Re: Brownstown Elementary School – Renovations and Additions
Recommendation – General Contractor Change Order Request 30

Re: Brownstown Elementary School Additions & Renovations
Change Order Request 40 – Bike Path Revisions
K&W Project No. 2265.007

RFP 10 | BIKE PATH REVISION

**Renovations and Additions to Brownstown
Elementary School
Conestoga Valley School District
51 School Lane
Brownstown, PA 17508**

SCALE:	1"=40 FEET
DATE:	JUNE 23, 2020
K&W PROJECT:	2265.007
DRAWN BY:	MRS
CAD DRAWING:	2265007-E_cd GRADE.dwg
SHEET:	CSD-17R

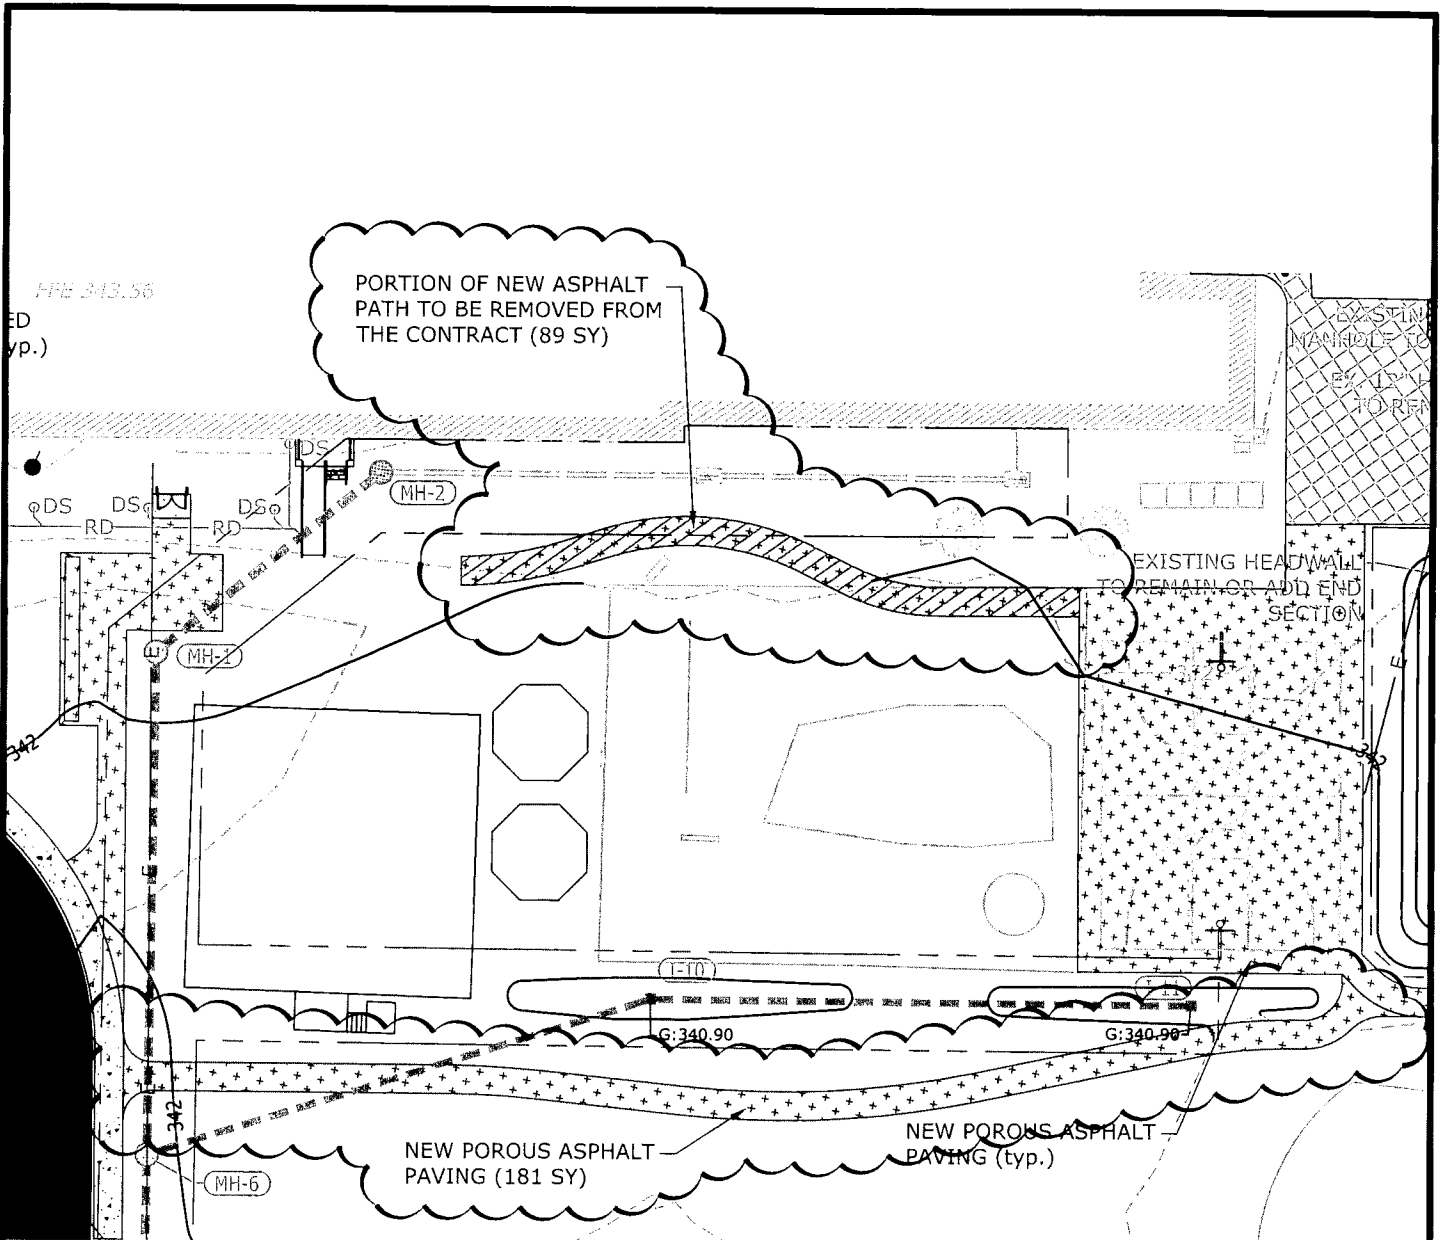
General Contractor is to provide a materials and labor price to revise the bike path as indicated on the attached Civil Sketch CSD-17R.

POROUS ASPHALT TO BE ADDED TO CONTRACT

POROUS ASPHALT PAVEMENT TO BE REMOVED FROM CONTRACT
